Access Compliance Report

Public Rights-of-Way

(Curb Ramps)

Intersection ID: 29562	Main Street: MCGLOUGHLIN WAY CT	Cross Street: TIOGA LN	Location: NE
ADA ID: 29CD2046867A	Ramp Type: PerpDiag	Initial Pass/Fail: Fail	Overall Compliance: No
Codes/Mitigation Info/Possible Solution		Field Measurements/Component Compliance	
Severity Score: 61.25

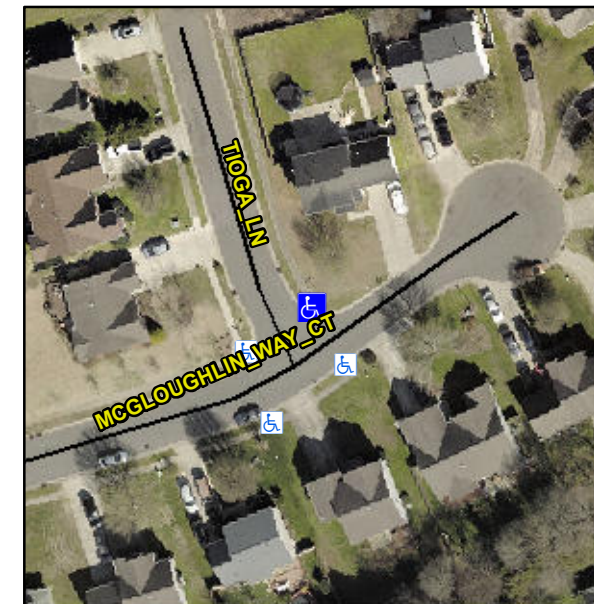
R304.5.1, R304.2.2, R304.5.3

Compliance	Description	Data	Compliance	Description	Data
N/A	Ramp Length (in)	50.0	No	Ramp Slope (%)	12.8
No	Ramp Width (in)	29.0	No	Ramp XSlope (%)	2.7
N/A	Flare Type LT	N/A	N/A	Flare Type RT	N/A
N/A	Flare Slope LT (%)	N/A	N/A	Flare Slope RT (%)	N/A
N/A	Flare Traversable LT?	N/A	N/A	Flare Traversable RT?	N/A
N/A	Landing Length (in)	N/A	N/A	DWS Provided?	N/A
N/A	Landing Width (in)	N/A	N/A	DWS Contrast?	N/A
N/A	Landing Slope (%)	N/A	N/A	DWS Length (in)	N/A
N/A	Landing X Slope (%)	N/A	N/A	DWS Full Width?	N/A
N/A	Landing Curb? (Y/N)	N/A	N/A	DWS Offset (in)	N/A
N/A	Shared Landing?	N/A			
N/A	Gutter Ponding?	N/A	N/A	Gutter Slope (%)	N/A
N/A	Gutter Lip Ht (in)	N/A	N/A	Gutter X Slope (%)	N/A
N/A	Painted X Walk1?	No	N/A	Painted X Walk2?	No
	X Walk 1 Direction	To SW		X Walk 2 Direction	To SE
N/A	X Walk 1 Width (in)	N/A	N/A	X Walk 2 Width (in)	N/A
	X Walk 1 Slope (%)	0.9		X Walk 2 Slope (%)	1.6
	X Walk 1 X Slope (%)	1.3		X Walk 2 X Slope (%)	1.5

Remove & Replace Curb Ramp With Two New Directional Ramps or Equivalent.
